PC STORMWATER REVIEW COMMENT N ORANGE BOXES WITH BLACK TEXT

Dw TN Apr		EOV PIN SUBSTATION	2						
IC	TRI-STATE		9						
	Generation and Transmission Association, Inc.	NOTES	5						
	A Touchstone Energy Cooperative		4						
Dat 12 Dat			б						
/10	P.O. Box 3369	TRI-STATE GENERATION & TRANSMISSION	2						
6/2	Denver, Colorado 80233	ASSOCIATION, INCORPORATED	1				Dwg. No.	Mfgr.	Drawing Title
.1	1110-264-606	UPDATED BY: TCLEMENT 10/10/2022 5:10 PM Contract:	No.	Date D	Dwn. Appd.	Revision	M.F.	Reference Drawings	ugs

SS	Dwn: TMC Appd	TRICTATE	FOX RUN SUBSTATION						
90) I:			9					
88		Generation and Transmission Association, Inc.	ACCESS DRIVENAY	5					
-A		A Touchstone Energy Cooperative	PLAN & PROFILE	4					
-0	Dat 12 Dat			ю					
1–	2/1	P.O. Box 3369	TRI-STATE GENERATION & TRANSMISSION	7					
00	6/2	Denver, Colorado 80233	ASSOCIATION, INCORPORATED	1			Dwg. No.	Mfgr. Drawing Title	
9	.1	1110-264-606	UPDATED BY: TCLEMENT 10/10/2022 5:10 PM Contract:	No.	Date Dw	Dwn. Appd.	Revision M.F.	Reference Drawings	
									,

Grading & Erosion Control Plan_V2.pdf Markup Summary

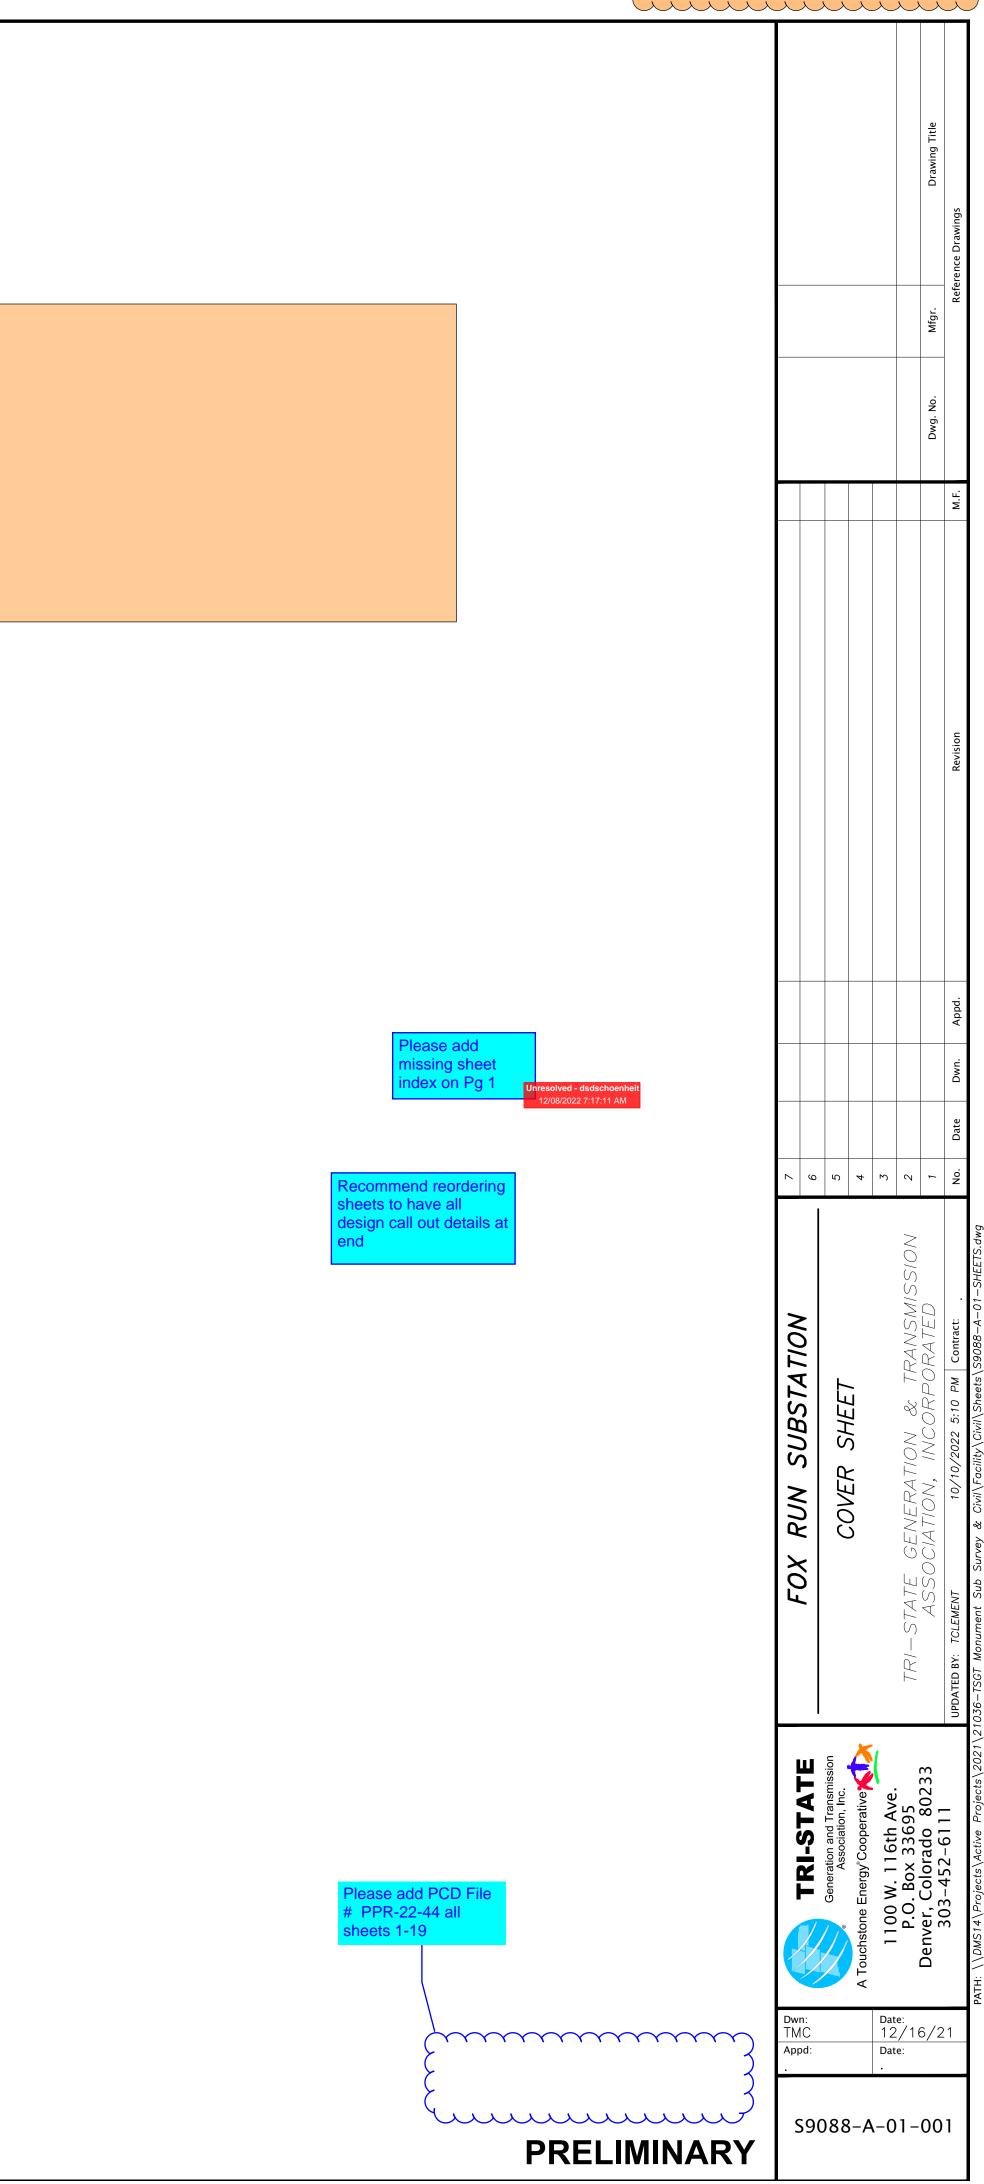
lease move EPC Standard G otes up to top pages. They are low on currently on page 18

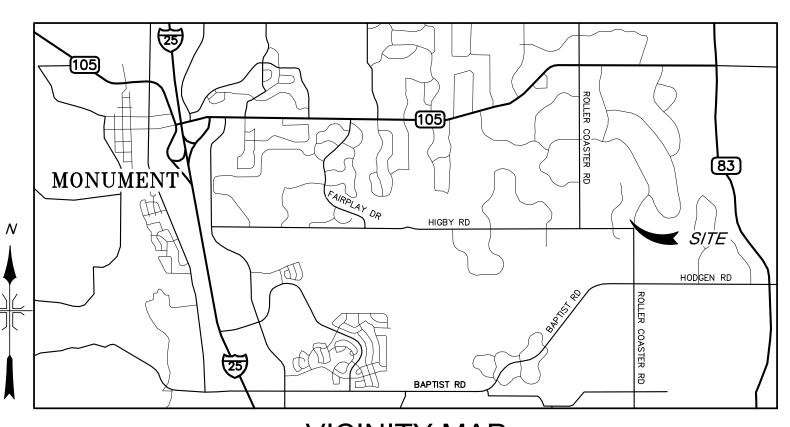
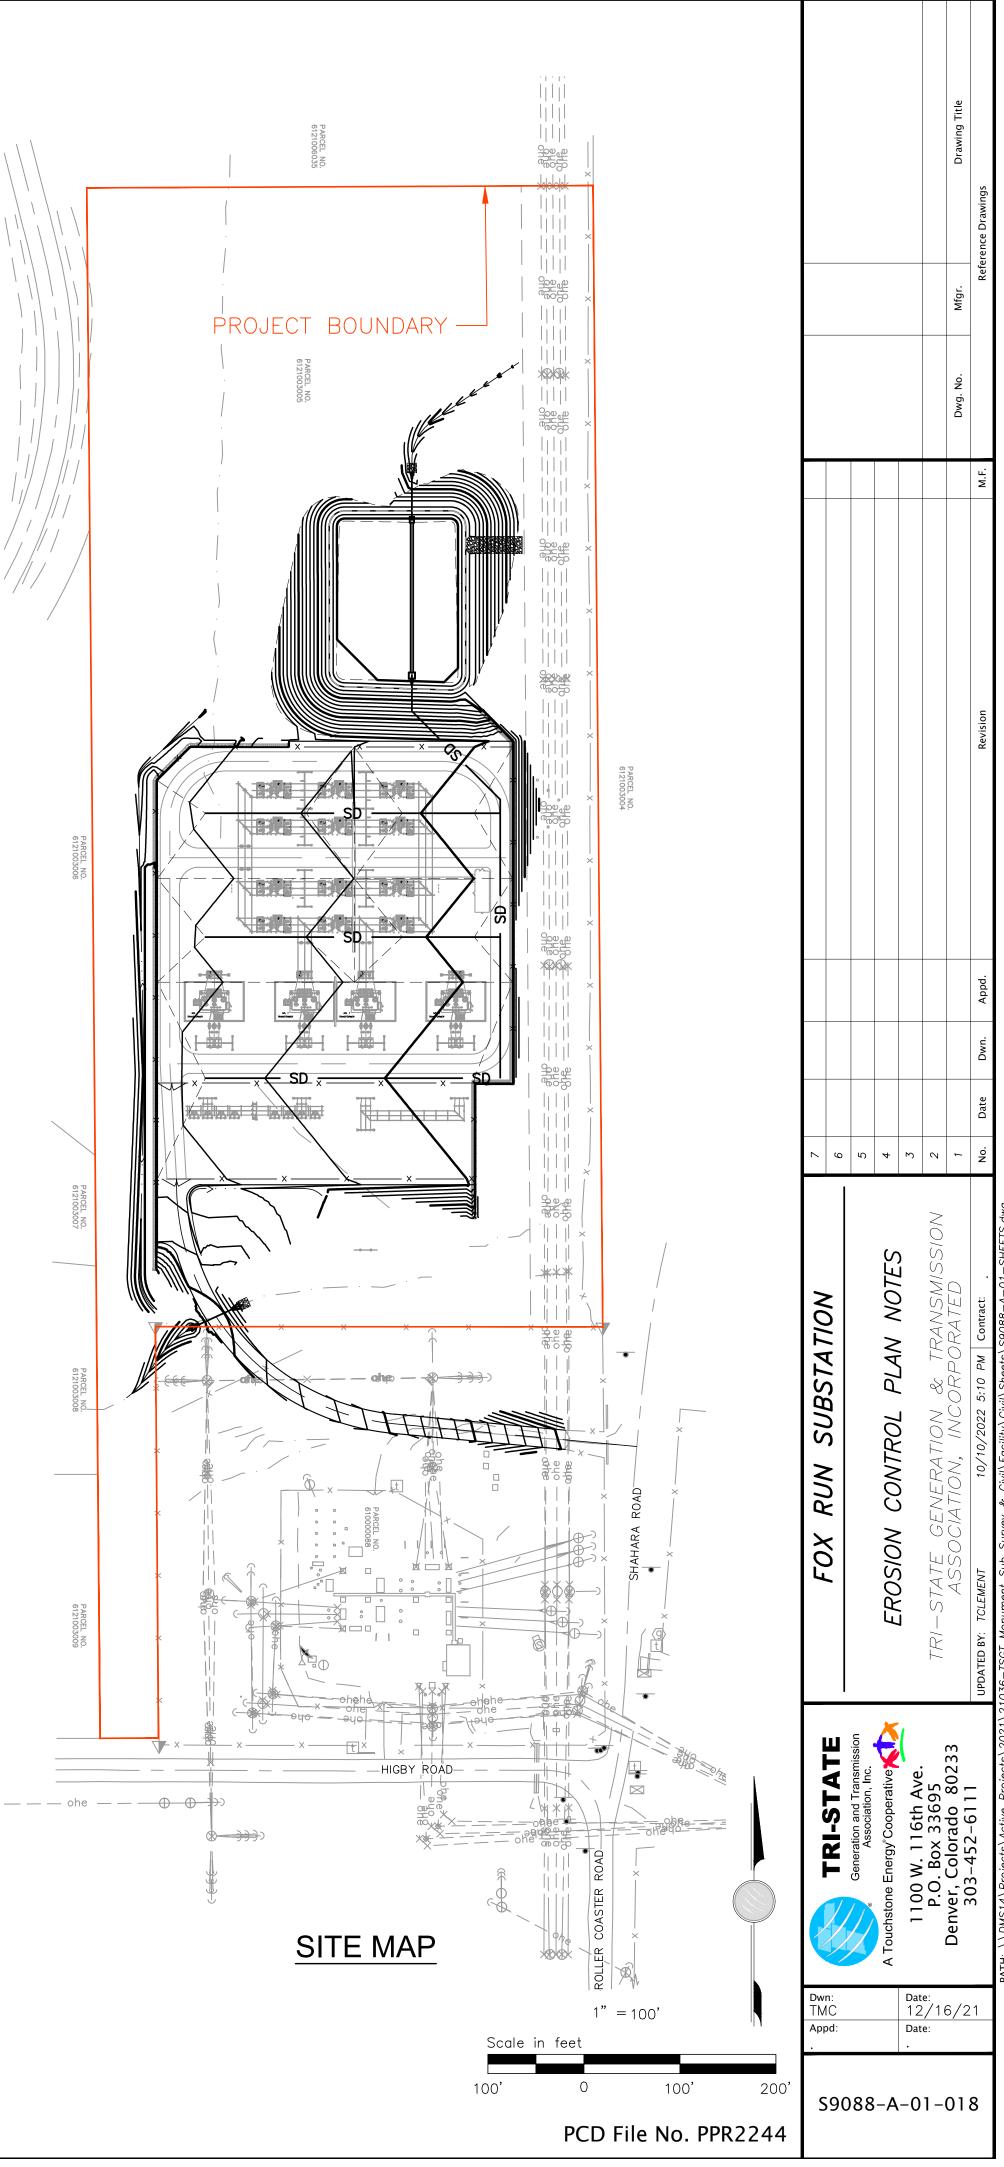
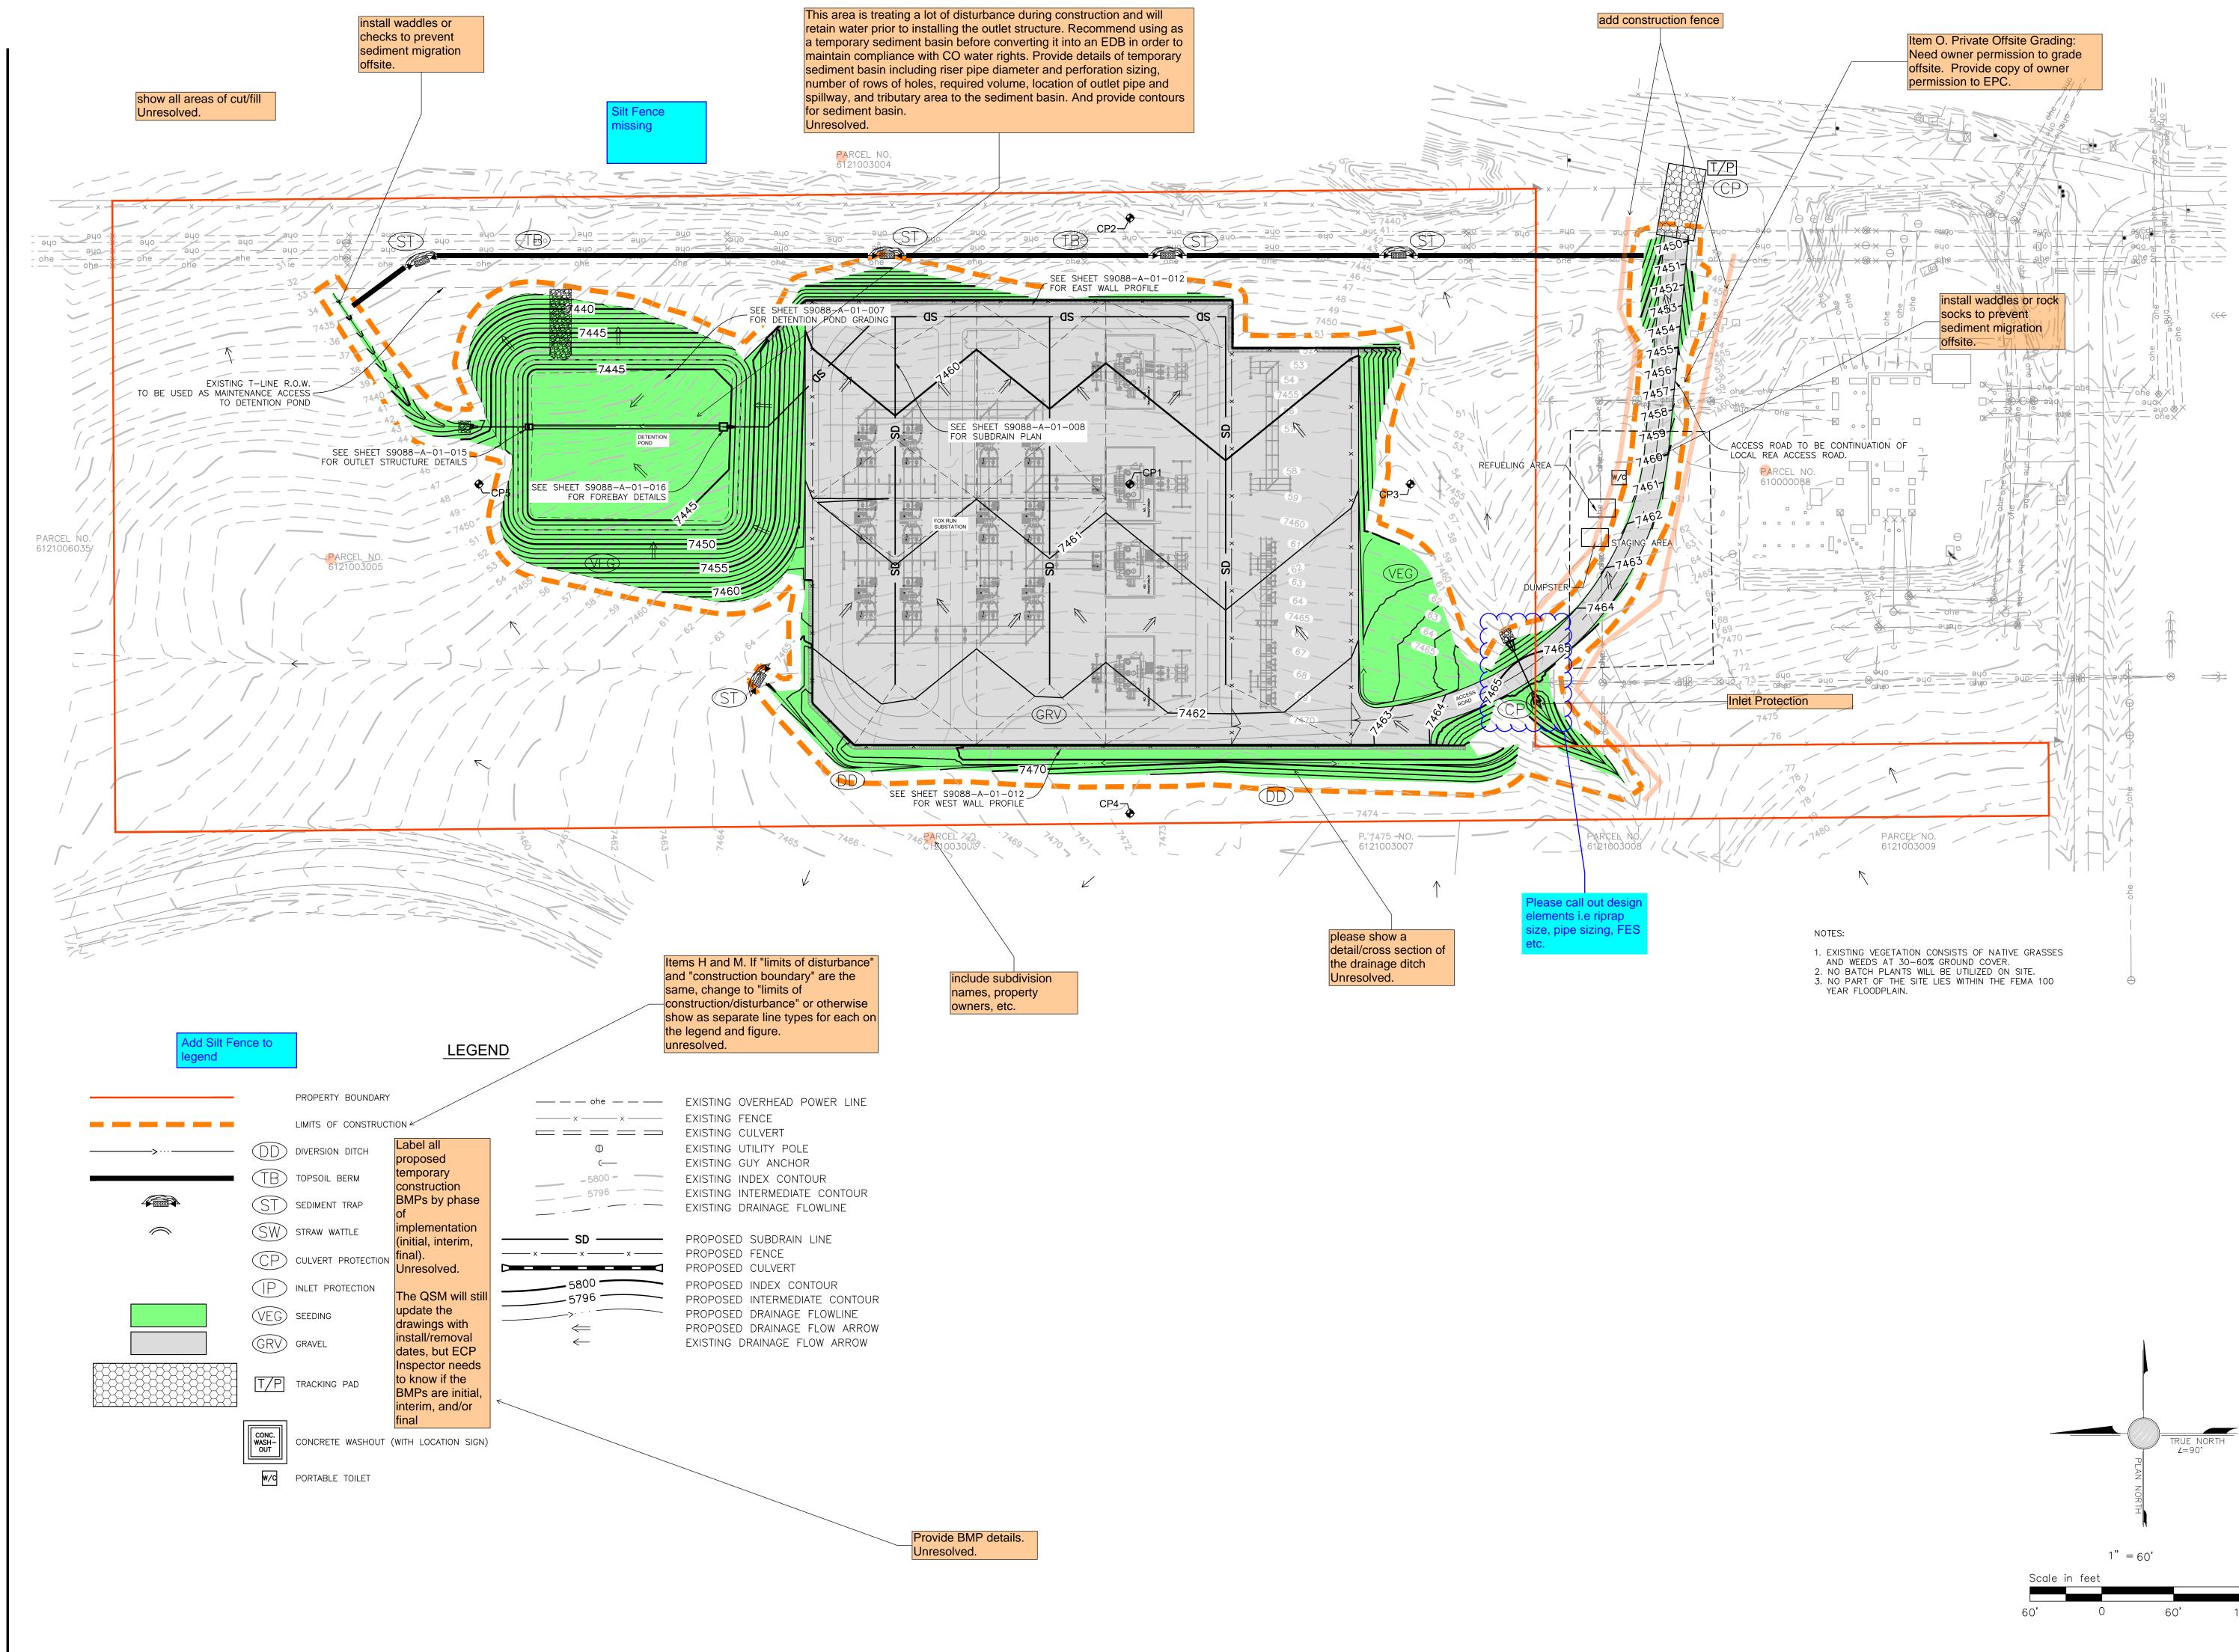
add: Joshua Palmer, P.E.

include date

move signature blocks to cover sheet

if you move the GEC notes, you dont need this sheet.
